Reviewer #1:

1. This is a well-written paper and presents interesting results evaluating radio occultation (RO) observations from a constellation of eight small commercial satellites developed by Tianjin Yunyao Aerospace Technology. The eight Yunyao satellites produced about 12,000 RO occultations per day over the period May-June 2023. The quality of these observations are evaluated based on mean and standard deviations of Yunyao refractivities computed by comparing with radiosondes and two models, as well as the penetration rates (% of profiles reaching levels near the Earth's surface). This paper is a potentially valuable contribution and should be published, but there are several areas where improvements are needed.

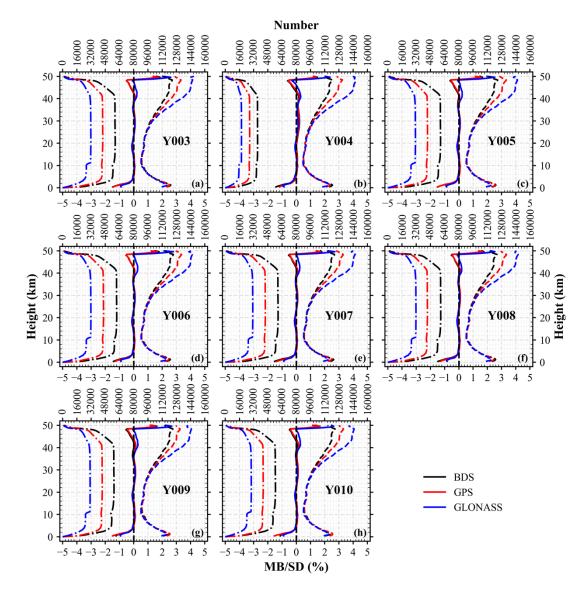
It would also be useful to include estimates of the error SD for the refractivity data up to 50-60 km, using the ERA5 and FNL model analyses as the other two datasets (extend Figs. 6-8 up to 50-60 km).

Response: Thank you very much for your suggestions. We apologize for not being able to provide results for the 50–60 km altitude range, as the ERA5 pressure-level data does not include atmospheric information at such high altitudes. The figure below shows the comparison between observations and ERA5 within the 0–50 km altitude range. As shown in the figure, the number of observations available for comparison decreases rapidly in the 40–50 km range, with almost no matching observations near 50 km, resulting in anomalous mean bias calculations. Therefore, we only presented results below 40 km in the manuscript. For Figs. 6–8 in the original manuscript, since we only obtained FNL data for the 26 mandatory levels (from 1000 hPa to 10 hPa), it was challenging to extend the results to higher atmospheric altitudes.
